Subject: WRD Comments on Proposed Plan for OU-2 Groundwater Contamination
Omega Chemical Superfund Site, Whittier, California

**Technical Memorandum
Omega Chemical Superfund Site
WorleyParsons
October 7, 2010**

**RE: TECHNICAL MEMORANDUM
 OMEGA CHEMICAL SUPERFUND SITE, WHITTIER, CALIFORNIA**

Figure 4-8
Hydrogeologic Cross Sections
with Location Map
 Omega Chemical Superfund Site

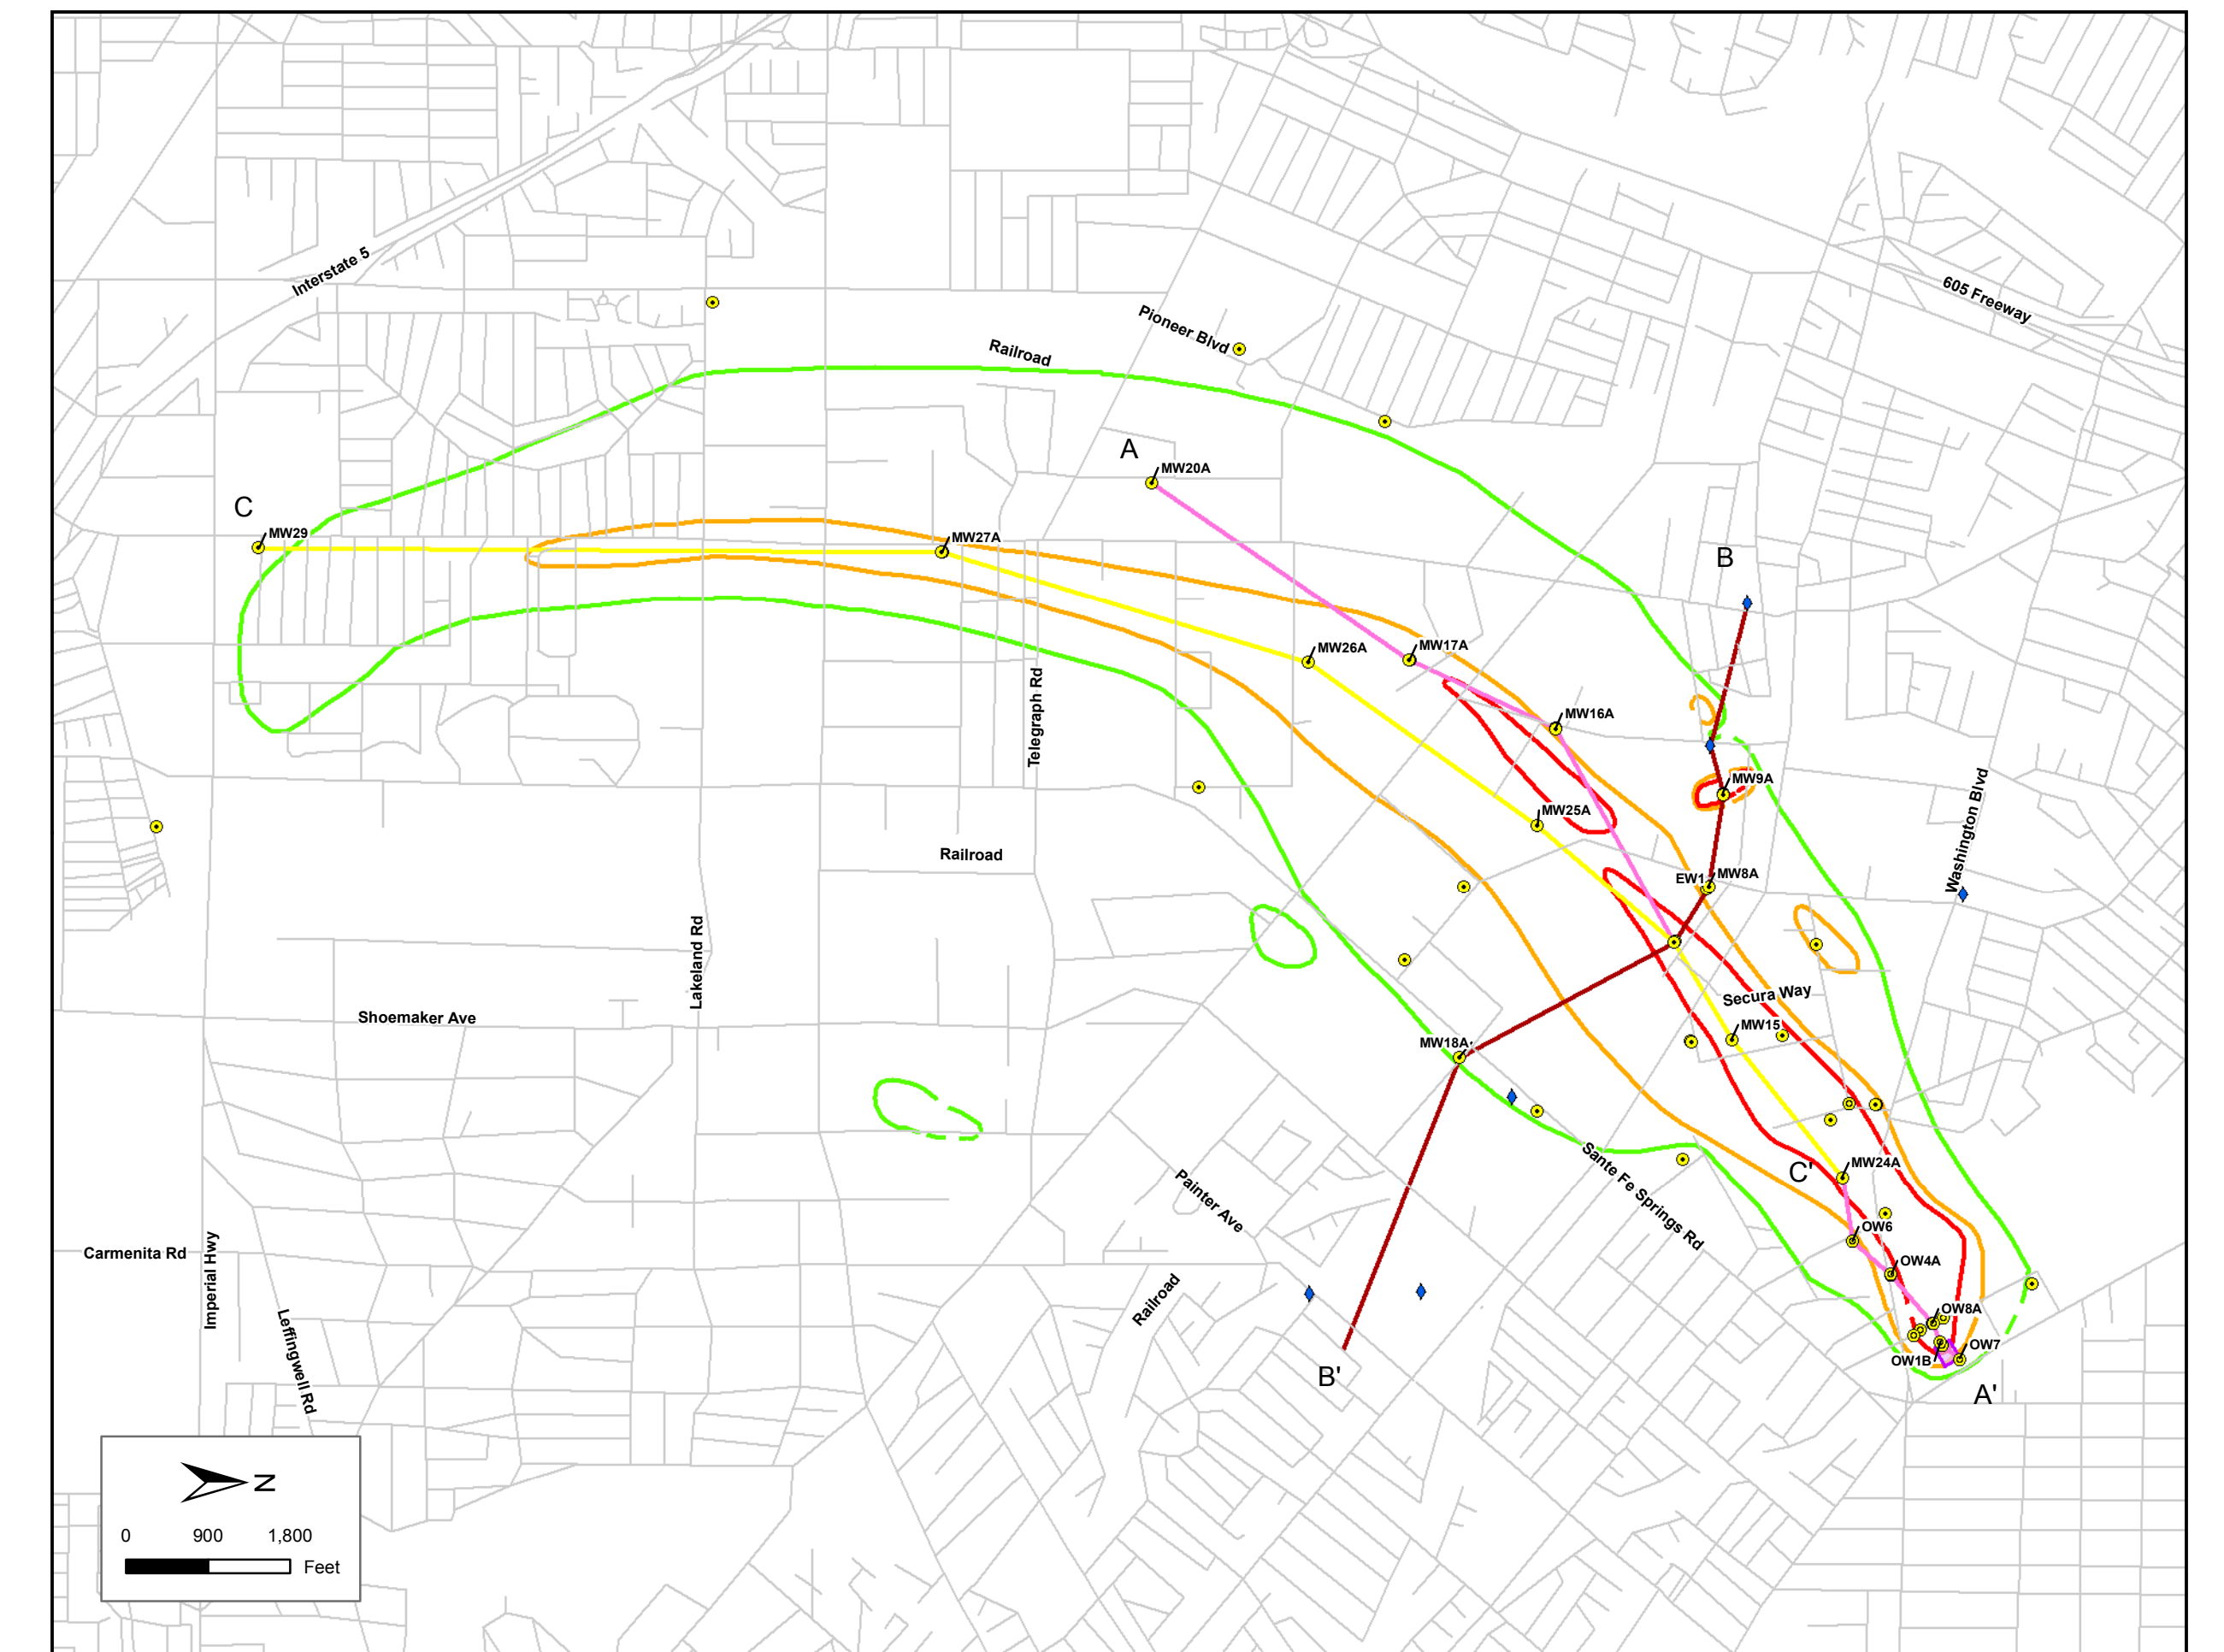
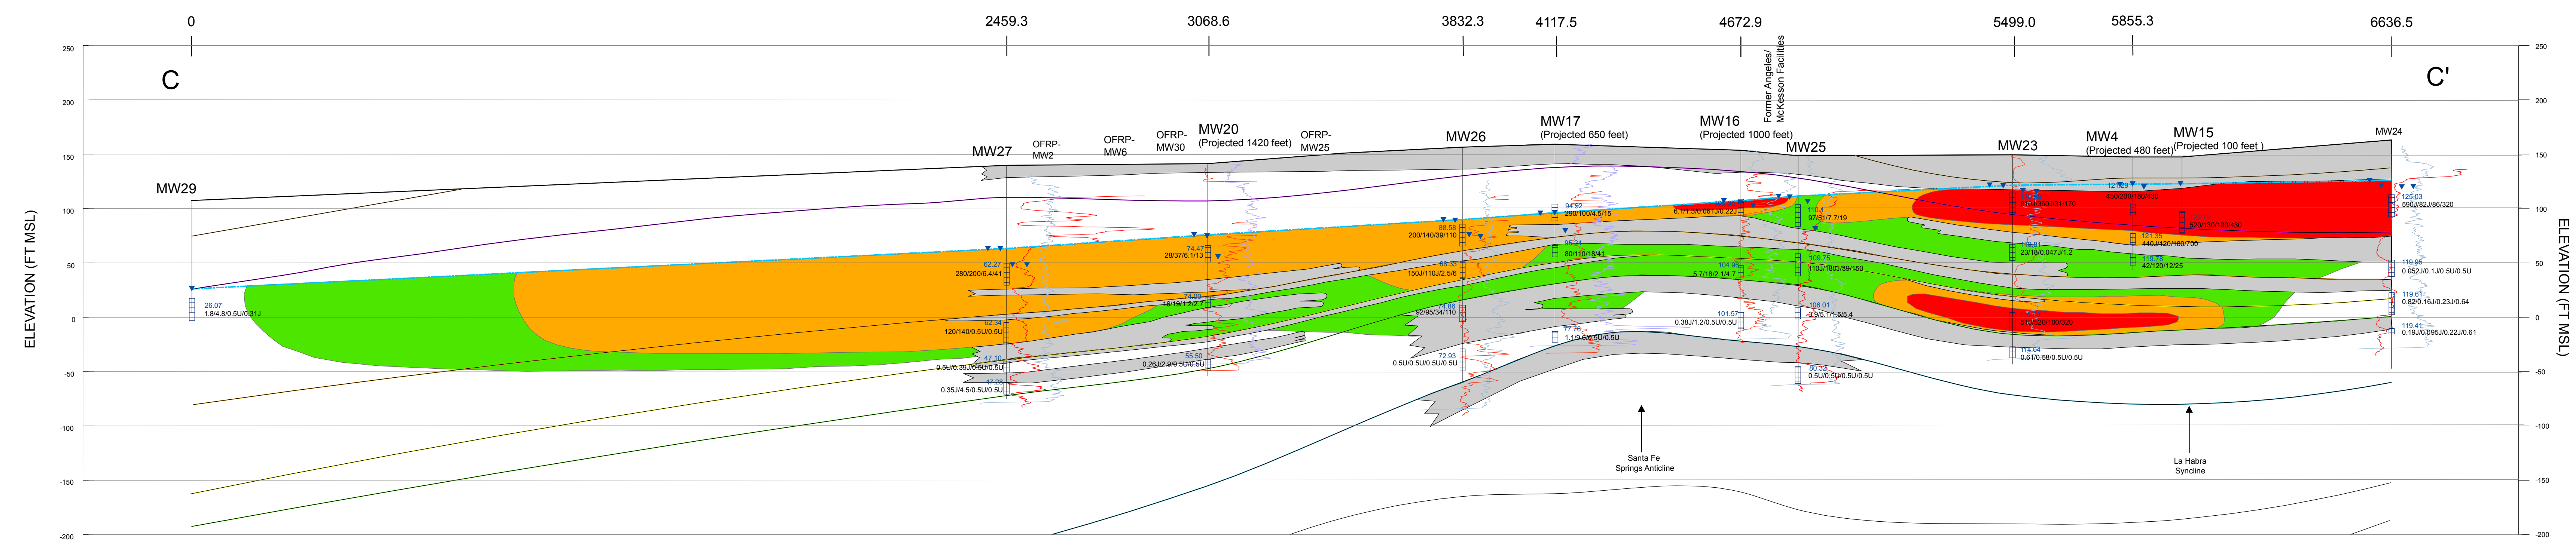
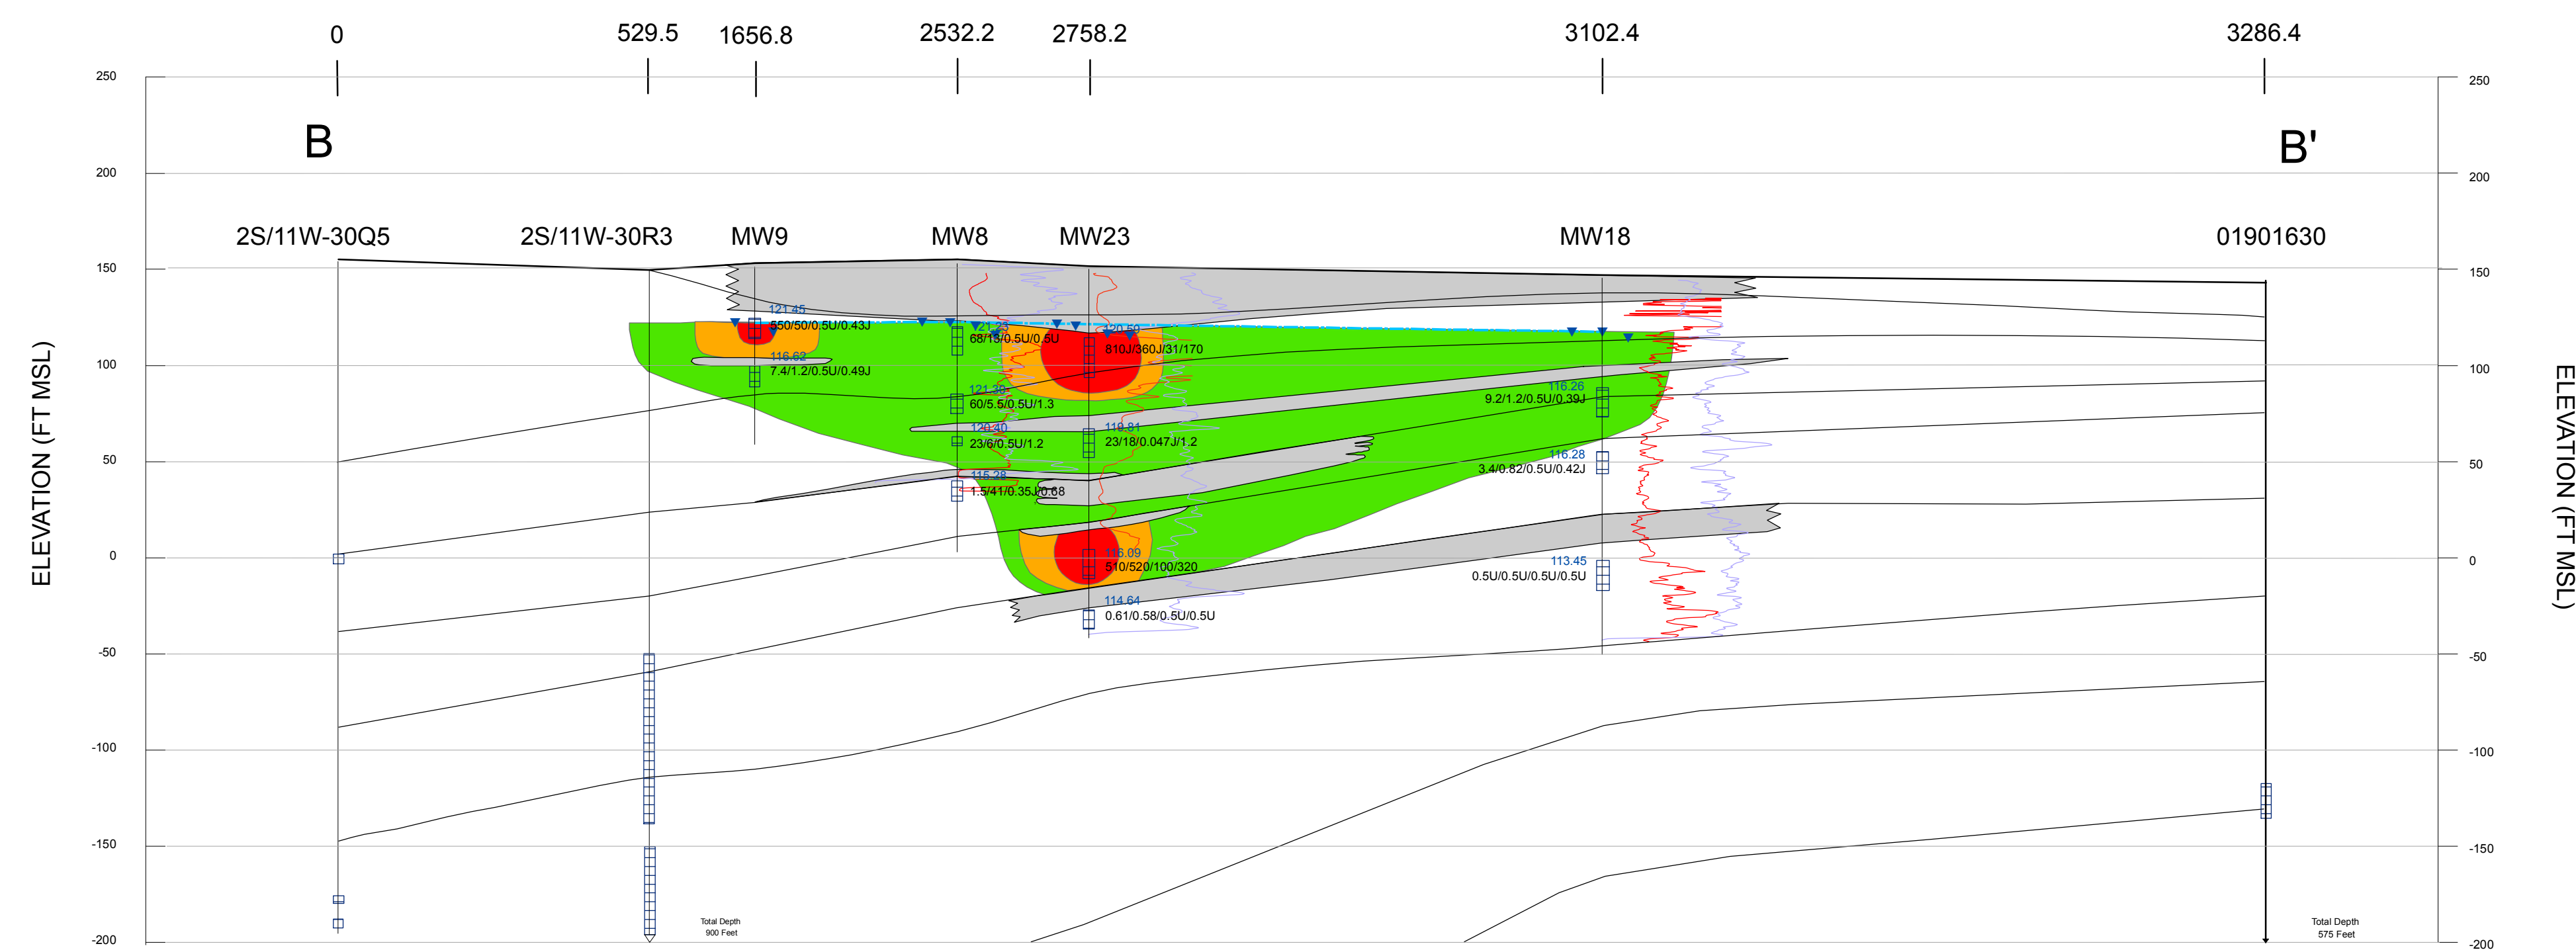
The vertical extent of contamination in the RI Report is likely under-represented (i.e., greater) in the downgradient part of OU2. The furthest downgradient monitoring well cluster with vertical delineation of the PCE or TCE plume is MW27; downgradient (south) of that well cluster, there is no vertical delineation of the plume. Figure 4-8 of the RI Report, cross-section C-C', shows the absence of

vertical delineation between MW27 and MW29. There are two key lines of evidence that indicate that contamination is likely deeper than indicated in the RI Report, as follows:
